P5002A-03

Information Only Service Note

P5002A Keysight Streamline USB Vector Network Analyzer

False alarm on self-test failure on firmware revision of A.13.40.02 - DDR3 memory removal

Self-test

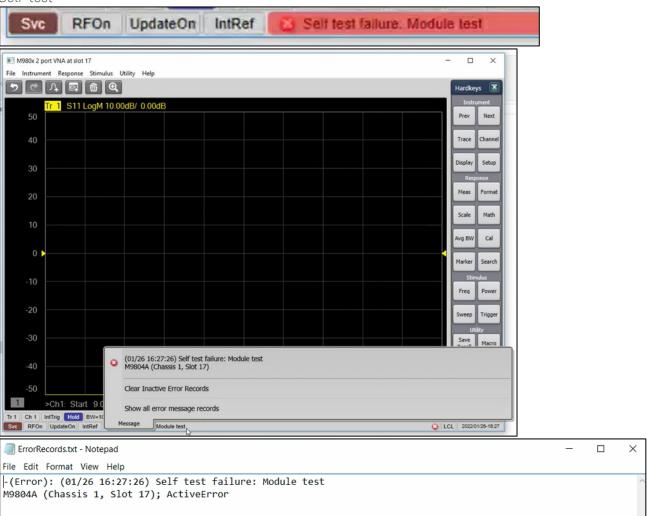
The on board DDR 3 memory in VNA is not in use since its release. With the removal of DDR 3 memory IC on newer P500xA VNA, right after firmware is launched, false alarm (self-test failure) will be reported as shown. This has no impact to VNA performance and specifications.

Similarly, firmware will report a false failure in Operator check. Shown are the error messages example on VNA firmware UI.

Since this DDR3 memory is not in use, newer firmware revision no longer consider it as the failure. Keysight recommends keeping VNA firmware up-to-date whenever it is possible.

For users with firmware revision of A.13.40.02, Update firmware to revision A.13.70.02 or newer to resolve this false alarm on self-test.
